Response to Submissions - SSDA 10424

Saint Ignatius' College Riverview

State Significant Development SSDA 10424 - Response to Submissions

New Ignis Stage 2 STEMP Building Project Development
2-60 Riverview Street and Tambourine Bay Road, Riverview

Figure 2. Overlay of Stage 2 and approved Concept Proposal (Source: PMDL Architects, 2021)

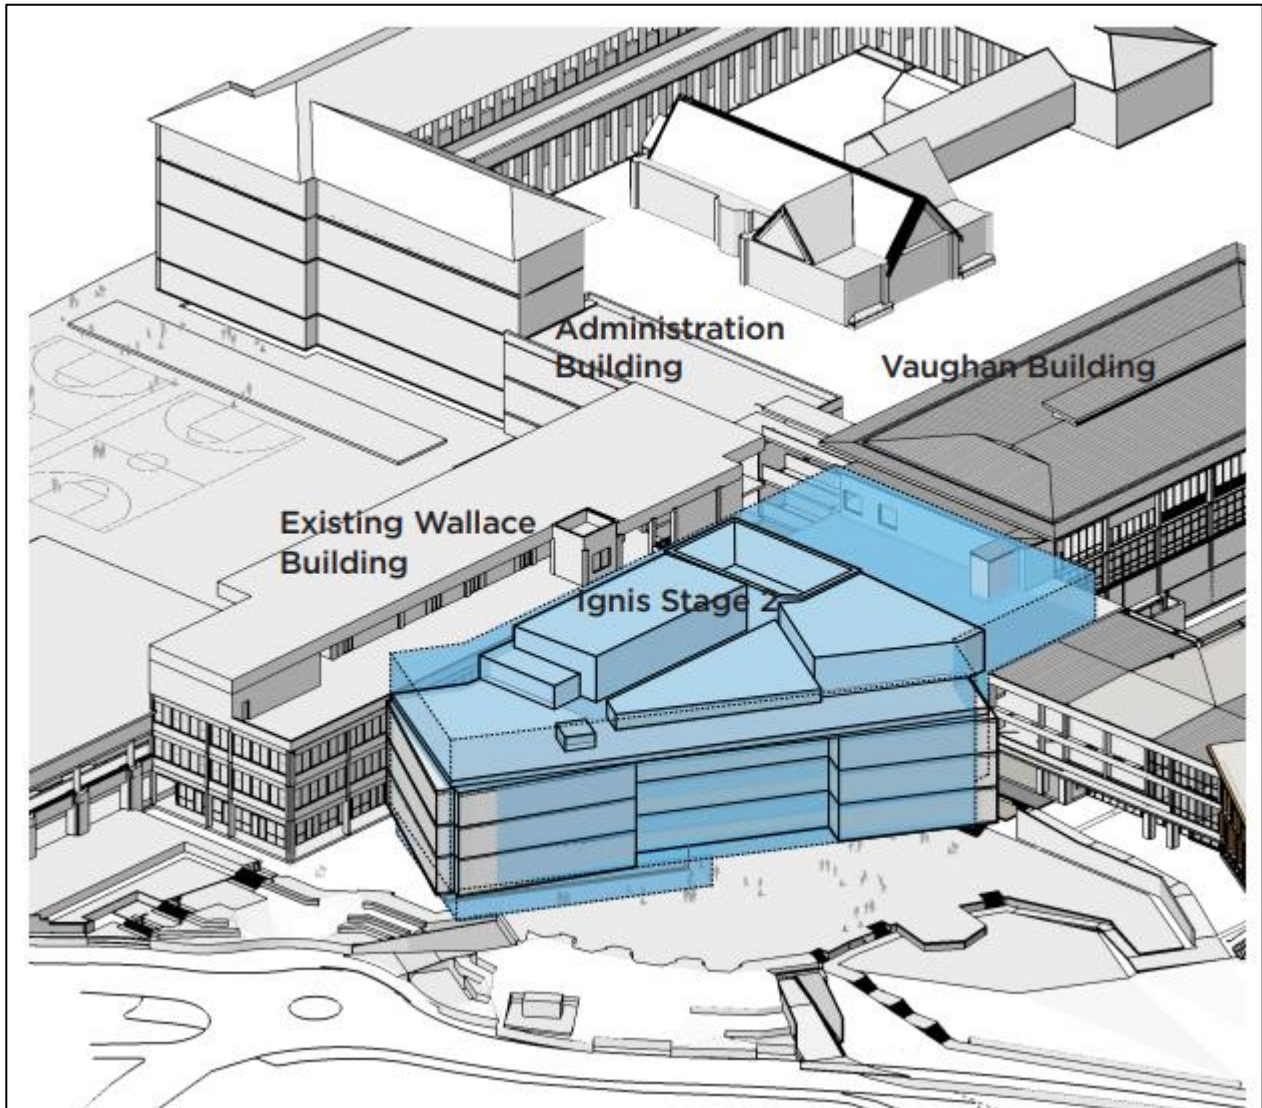
As requested by DPIE, **Figure 2** below overlays the proposed Stage 2 plans and the approved Concept Proposal demonstrating compliance between the proposed and approved site layouts. The New Ignis Stage 2 STEMP Building is shown within the approved Concept Proposal building envelope (blue volume). The existing Wallace and Administration buildings are retained in Stage 2. In a future stage (subject to further applications), the existing Wallace and Administration buildings will be demolished and the new Student Node-Link building (green volume in Figure 1) will be constructed.
